**COUNCIL ASSESSMENT REPORT**  
SYDNEY WESTERN CITY PLANNING PANEL

<b>PANEL REFERENCE &amp; DA NUMBER</b>	PPSSWC-370 – DA-520/2023
<b>PROPOSAL</b>	Demolition of all existing structures, tree removal and construction of a Residential Flat Building with two (2) levels of basement parking and a change of use of the ground floor to a Centre Based Childcare Facility for 90 children with lot consolidation and associated civil and landscaping works.
<b>ADDRESS</b>	7 Castlereagh Street Liverpool, 6,8.10 and 12 Copeland Street Liverpool
<b>APPLICANT</b>	Castlereagh Street Developments Pty Ltd
<b>OWNER</b>	Castlereagh Street Developments Pty Ltd
<b>DA LODGEMENT DATE</b>	4 October 2023
<b>APPLICATION TYPE</b>	Development Application
<b>REGIONALLY SIGNIFICANT CRITERIA</b>	Capital Investment Value >\$30m
<b>CIV</b>	\$42,260,646 (excluding GST)
<b>CLAUSE 4.6 REQUESTS</b>	<p>Clause 4.3 Height of Buildings under Liverpool Local Environmental Plan 2008</p> <p>Clause 7.4 Building Separation in the Liverpool City Centre</p>

The Development Application (DA) DA-520-2023 seeks consent for demolition of existing structures and the construction of two (2) 11-storey residential flat buildings consisting

**Figure 7:** the development showing extent of the setbacks to the northern boundary.

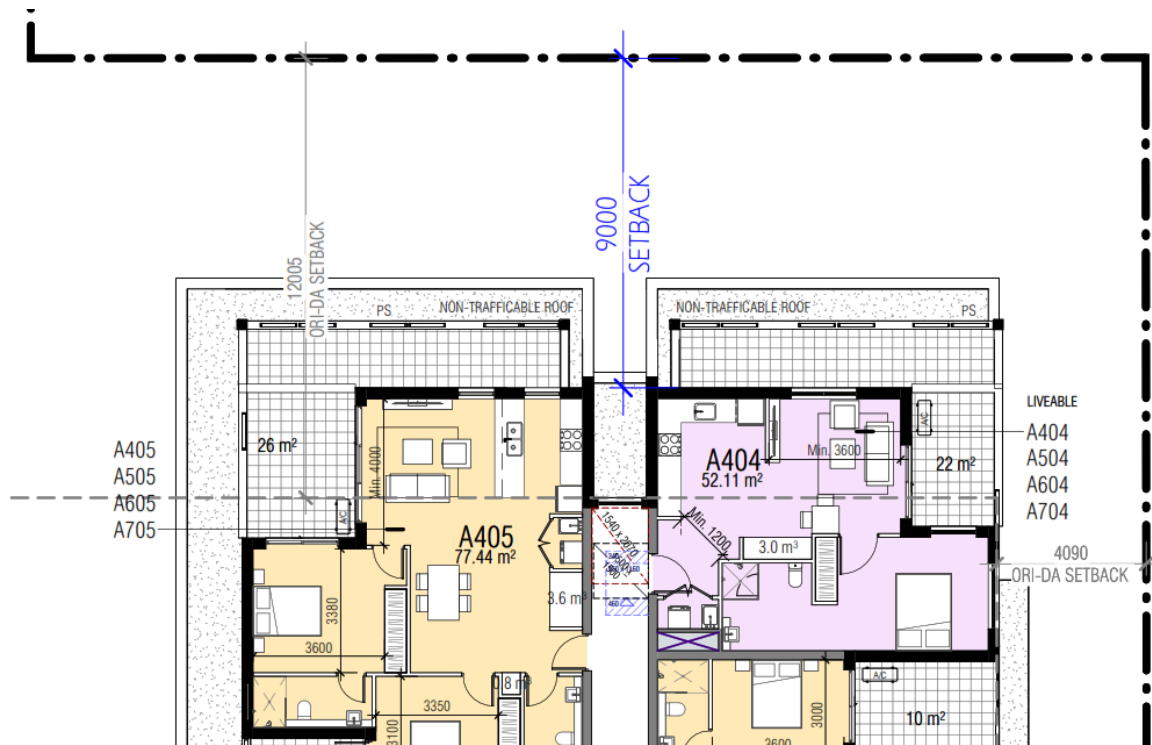
Block A and Block B also have a 0m setback from the southern boundary development, which was an approved RFB under DA-508/2017 which has yet to begin construction. The variation extent is 100%.

The built form complies with the 9m required setback; however, the balconies intrude on the setback as identified above, and demonstrated below.

**Figure 8:** The development showing the extent of the setbacks to the southern boundary

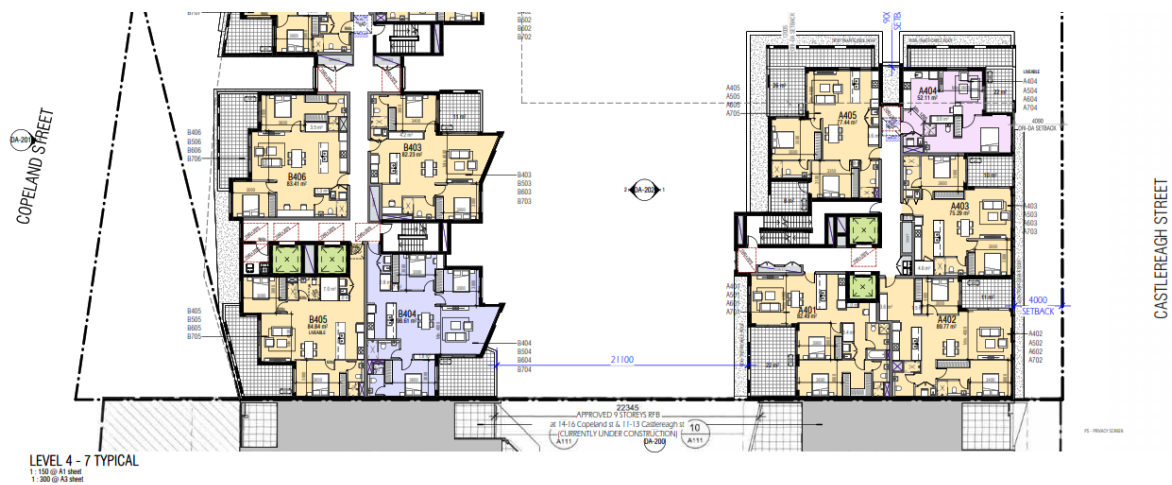
Consequently, pursuant to Clause 4.6 of the LLEP 2008, the applicant has submitted a written request seeking a variation to the building separation as prescribed by Clause 7.4.

**Figure 9:** Approved development from previous DA.

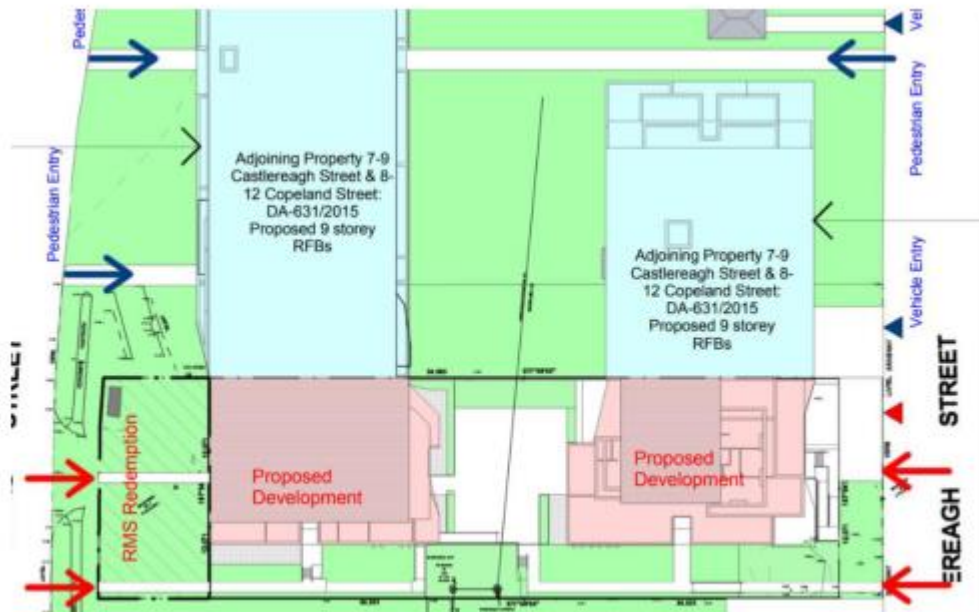
*As detailed on Figure 3 below, this application was also designed as being built to the boundary. Therefore, the relationship of zero lot lines between the subject site and that to the southern neighbour has already been approved. No change to this relationship is sought through this application, rather this is replicated with 0m southern boundary setback proposed.*

*This relationship as previously approved between the subject site and the southern neighbour is being replicated with this proposal. This zero-lot boundary alignment of built form was previously considered appropriate and no change is being proposed.*
